March 9, 2015

Environmental Protection Agency
EPA Docket Center (EPA/DC)
Mail Code: 28221T
1200 Pennsylvania Ave, NW
Washington, DC 20460

Attn: Docket ID No. EPA-HQ-OAR-2003-0119

The Coalition for Responsible Waste Incineration (CRWI) appreciates the opportunity to submit comments on *Standards of Performance for New Stationary Sources and Emission Guidelines for Existing Sources: Commercial and Industrial Solid Waste Incineration Units: Proposed Rule*. 80 Fed. Reg. 3,018 (January 21, 2015). CRWI is a trade association comprised of 25 industry members. A number of CRWI members own and operate facilities that will be impacted by this rulemaking.

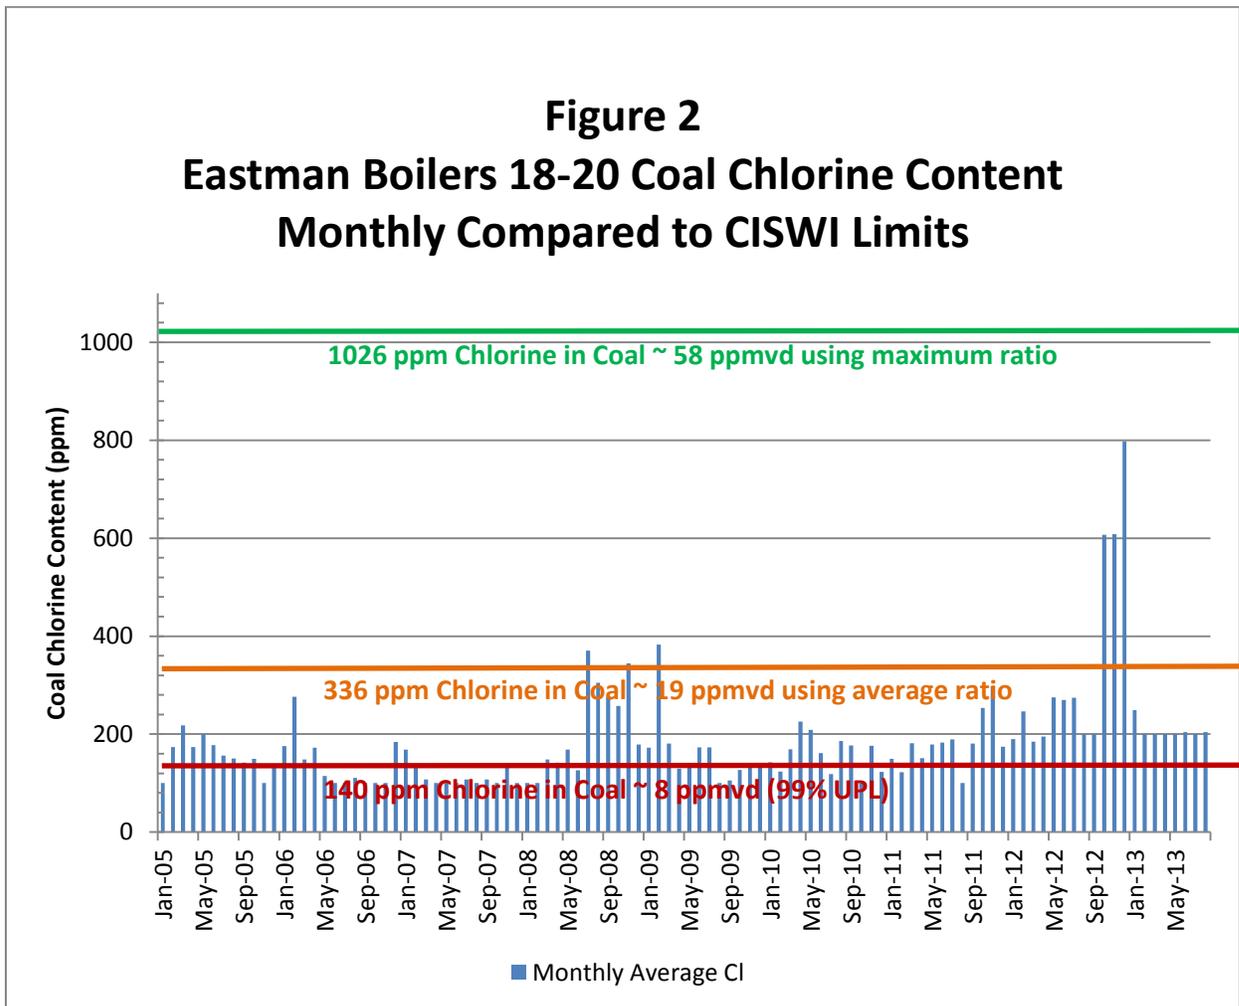
To support this adjustment in the standard, Eastman graphed the data they submitted to develop the fuel variability factor as monthly averages. They show this as Figure 2 in their comments (copy shown below). While a monthly average is not exactly the same as a 30-day rolling average, for this purpose, it is essentially equivalent.

This data shows considerable variation. It can easily be seen from the figure that the 58 ppmv number is the only proposed standard in Table 2 of the preamble that the top performing unit can meet all of the time. If the standard were left at 13 ppmv (from the 2013 final rule), the top performer would fail to meet that standard numerous times. If the standard were set at 19 ppmv, the top performer would fail to meet that standard six times over an eight year period. Thus, to make the HCl emissions limit achieved in practice for the top performing source, EPA has no choice but to set the final HCl emissions limitation at 58 ppmv.

The courts have plainly stated that the top performers should be able to meet the standards under the worst foreseeable conditions. *Nat'l Ass'n of Clean Water Agencies v. EPA*, 734 F.3d 1115, 1158 (D.C. Cir. 2013). This would not be possible without using the maximum fuel variability factor to modify the UPL calculation to develop the standard. Thus, CRWI supports the use of this fuel variability factor and believes that EPA properly used data provided by Eastman to estimate what the top performers could meet under all foreseeable conditions.
